## First Revision No. 43-NFPA 76-2022 [ Global Input ]

## First Revision No. 57-NFPA 76-2022 [ Global Input ]

Figure 8.8.2.1.2 Cable Substitution Hierarchy.

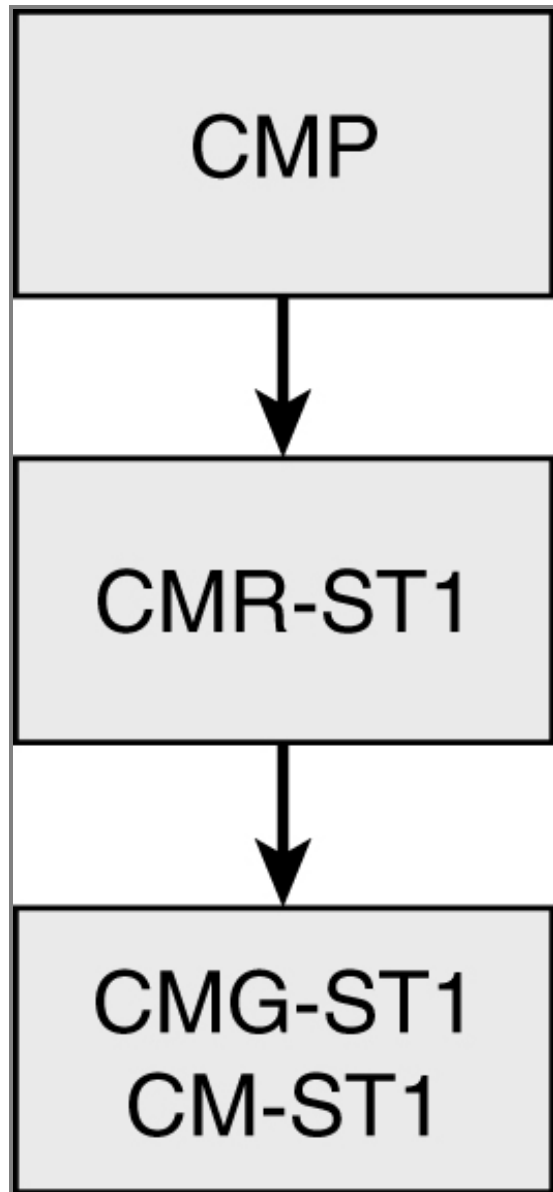
The substitutions for telecommunications cables that are shown in Table 8.8.2.1.2 and illustrated in Figure 8.8.2.1.2 shall be permitted.

**Committee Statement:** This FR is editorial. Its intent is to illustrate and clarify requirements that are in the current edition of the standard; no technical changes are proposed. Since telecommunications cables, raceways, and cable routing assemblies need to be marked in order to ensure that they meet listing requirements, including marking requirements improves usability of the standard. Displaying substitution requirements in a table and an illustration improves the usability of the standard. ANSI has been removed from UL document titles.

Figure 8.8.2.3.2

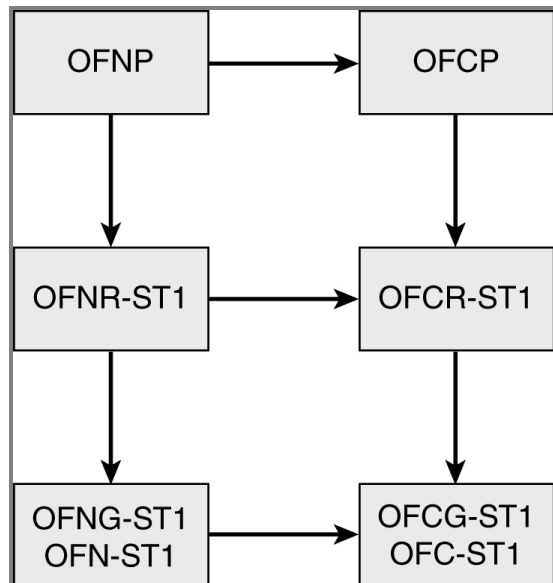
The substitutions for optical fiber cables shown in Table 8.8.2.3.2 and illustrated in Figure 8.8.2.3.2 shall be permitted.

**Figure 8.8.2.5.2**

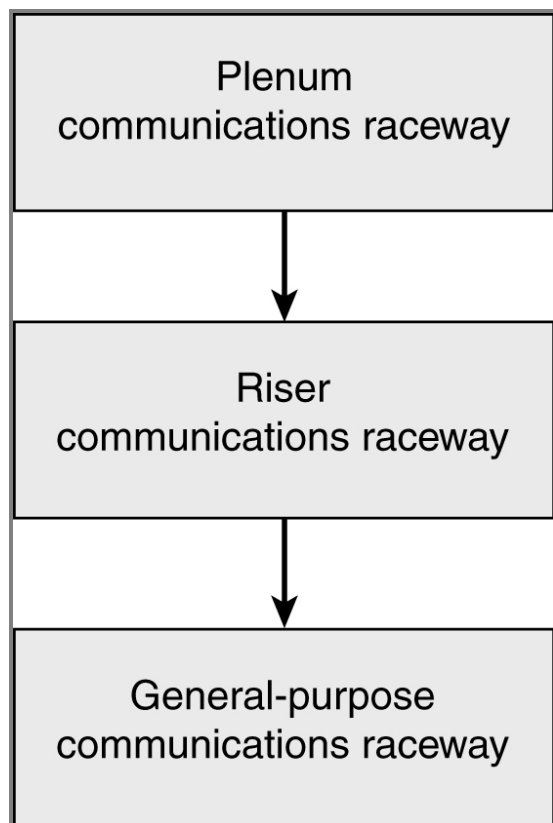
The substitutions for communications raceways shown in Table 8.8.2.5.2 and illustrated in Figure 8.8.2.5.2 shall be permitted.

Figure 8.8.2.6.2

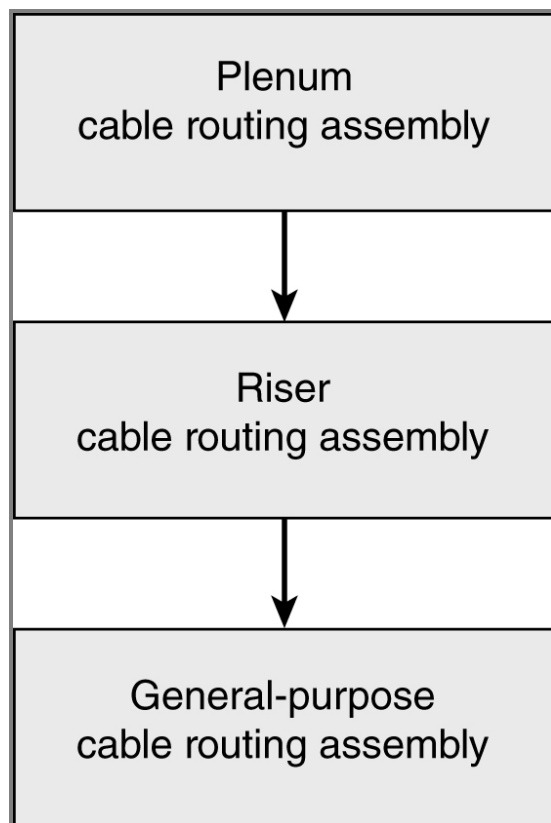
The substitutions for cable routing assemblies shown in Table 8.8.2.6.2 and illustrated in Figure 8.8.2.6.2 shall be permitted.
